Designer Washing & Dyeing Limited

19 November 2023

2. Observations

Figure 2.3D OF THE ETABS MODEL

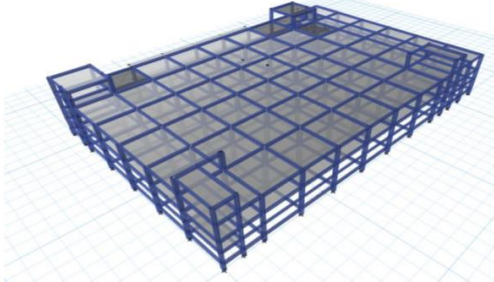
Observation-1: Inconsistencies in design report. (Washing building).

Description: A Design Report was provided for this structure where the intermediate moment resisting frame (IMRF, R=8) was considered without any justification. Also, the consideration of soil bearing capacity doesn't match with the soil test report. Moreover, the number of concrete cylinder test reports found on site doesn't comply with the frequency of testing requirements as per BNBC (Part VI, Chapter 5, 5.12.2), but in the design report, design strength 4500 psi considered for column and 3000 psi consider for beam & slab. The building engineer is required to revise the design report for the actual framing system with proper justification and confirm the design strength of in situ concrete by taking 100 mm diameter core (min 4 nos) from lower tier columns and revise foundation adequacy calculation. Submit the revised design report to the RSC for review.

SL No.	Observation	Action Plan	Timeline
01.	Inconsistencies in design report. (Washing building).	The building engineer is required to revise the design report based on in-situ material strength, actual soil bearing capacity & software-based analysis model and submit the documents to the RSC for review.	within 6 weeks

Observation 2: Column and foundation stress above normal for possible vertical extension.
(Washing Building)

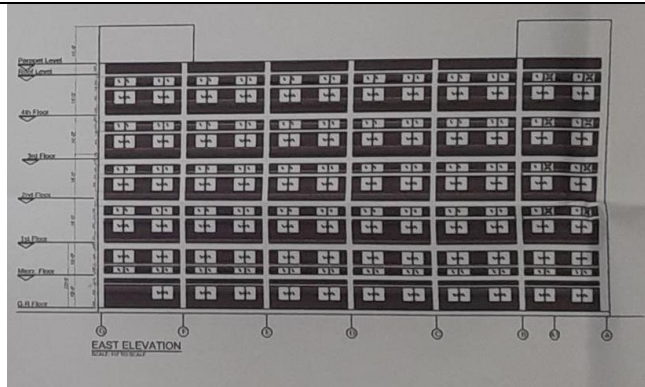
Description: This building is permitted for 5 (G+M+4) storied from PWD, Dhaka (Local Authority). Currently, the building is two storied. Proposed drawings were available during the inspection. Considering the proposed Five-storied building and minimum concrete strength, the stress in the column exceeds the normal design limit. However, the building engineer is required to carry out a Detailed Engineering Assessment (DEA) considering the BNBC provision and complete necessary remedial works prior to the commencement of further construction.

03.	Inconsistencies in design report. (Washing building).	Carry out suggested remedial works if required.	within 6 months
04.	Possible vertical extension. (Washing Building)	In case of extension, the building engineer is required to carry out a Detailed Engineering Assessment (DEA) considering the BNBC provision and complete necessary remedial works prior to the commencement of any further construction.	within 6 months

Observation-3: Mismatch in as-built drawing. (Washing Building)

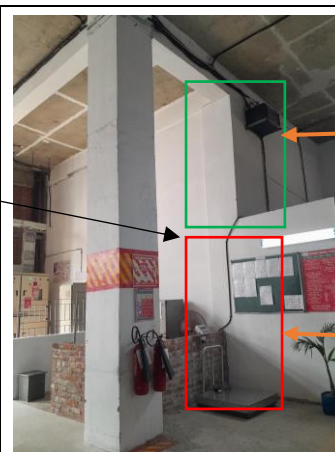
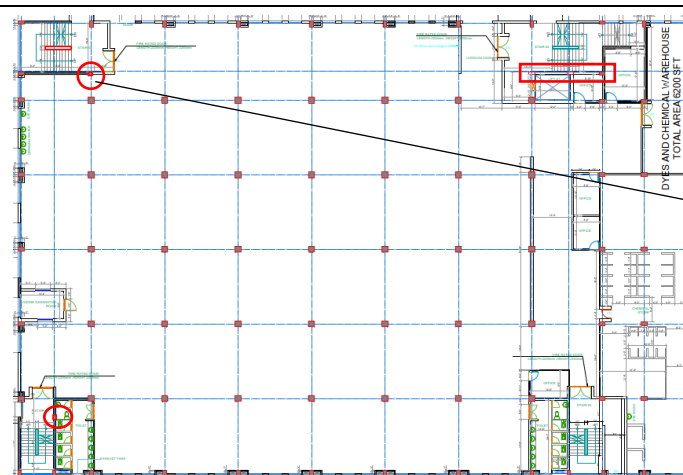
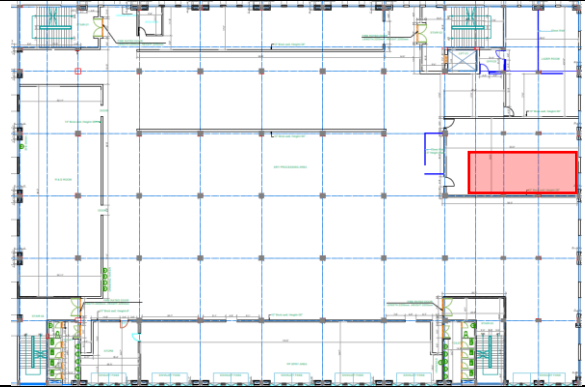
Brick column

RC column up to 1st landing of stair.

Marked ground-floor columns were found up to 1st landing of stairs.

Description: During the inspection, some mismatch was found in the as-built drawing. Individual column layout was missing in the as-built drawing. There is a variation in column layout between the ground floor and the rest of the floors. The building engineer is required to survey the full structure and prepare accurate as-built drawings including floor wise column layout.

05.	Mismatch in the as-built drawing. (Washing Building)	The building engineer is required to survey the full structure and prepare accurate as-built drawings.	within 6 weeks
